River Bend Station - Unit 1
Docket No. 50-458

ASIATIC CLAM CONTROL PROGRAM

LICENSING DOCUMENT INVOLVED: Technical Specifications

ITEM: 6.8.4.d

FIGURE 9.2-24

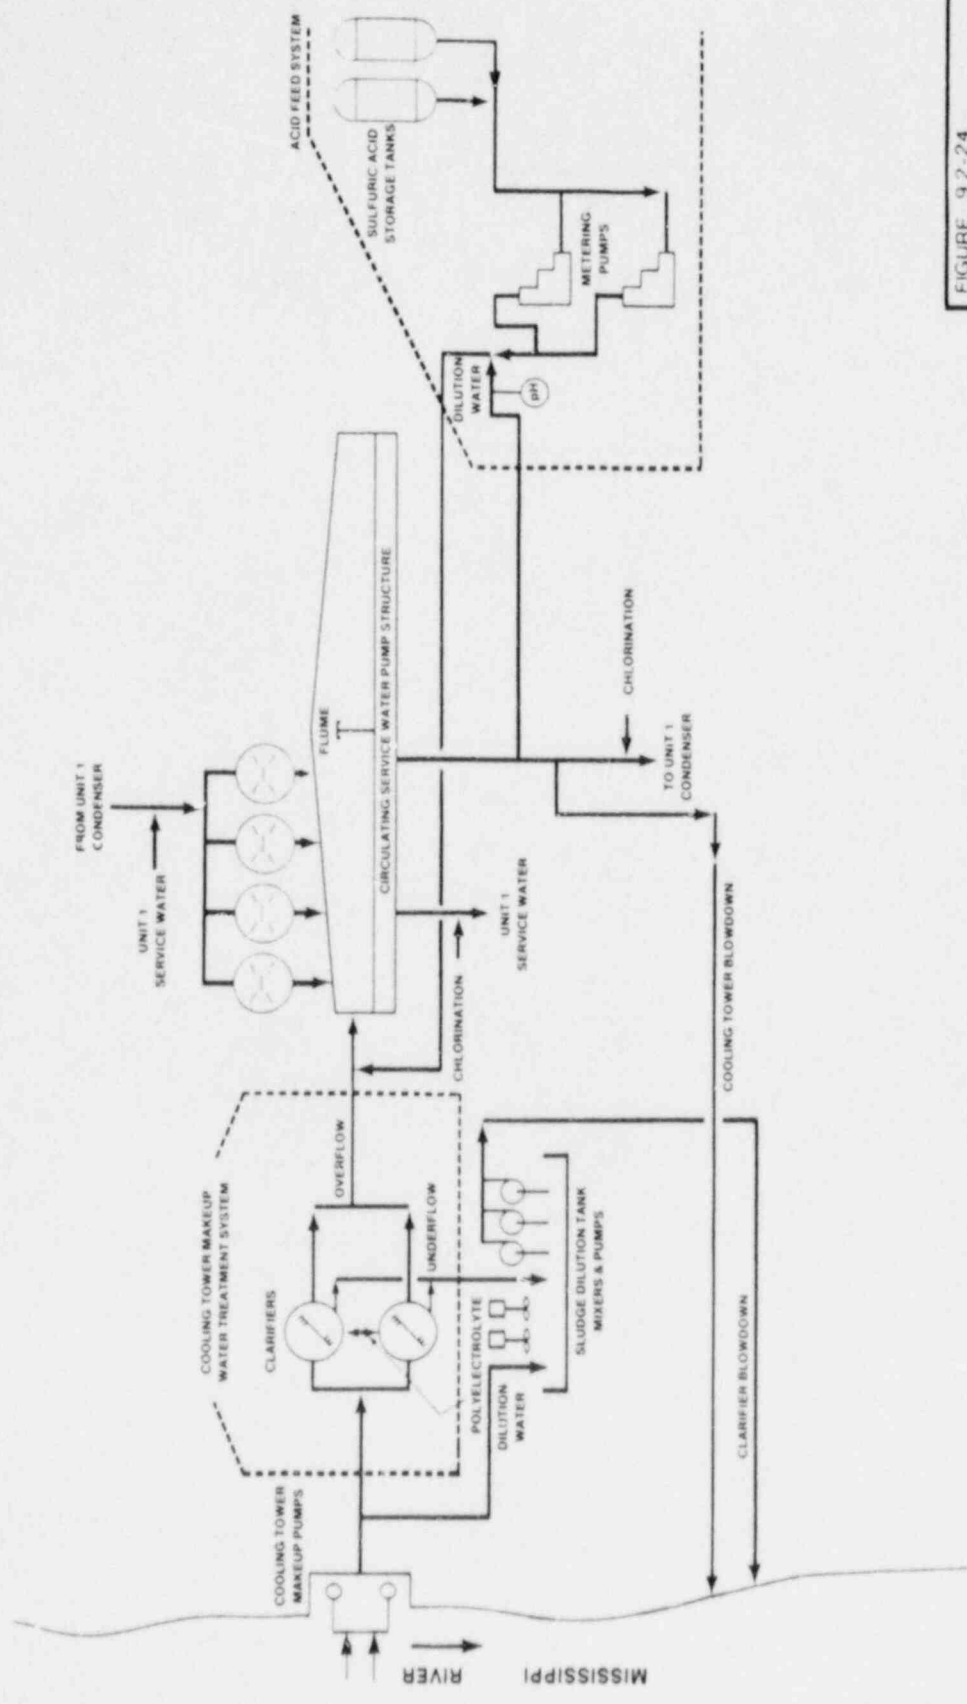
The only path of Mississippi River water intake to the RBS circulating/service water system is via the makeup pumps located in the embayment area (see attached figure). Monitoring for adult/large juvenile clams will continue in the embayment where plant cooling water makeup is withdrawn (Mississippi River water). Also, larval/smaller juvenile clams will continue to be monitored in the influent to the clarifiers. For these reasons, GSU concludes that suspension of river channel sampling will not decrease the effectiveness of the ACCP to monitor the presence of Corbicula in the source of makeup water to the cooling tower circulating/service water system.
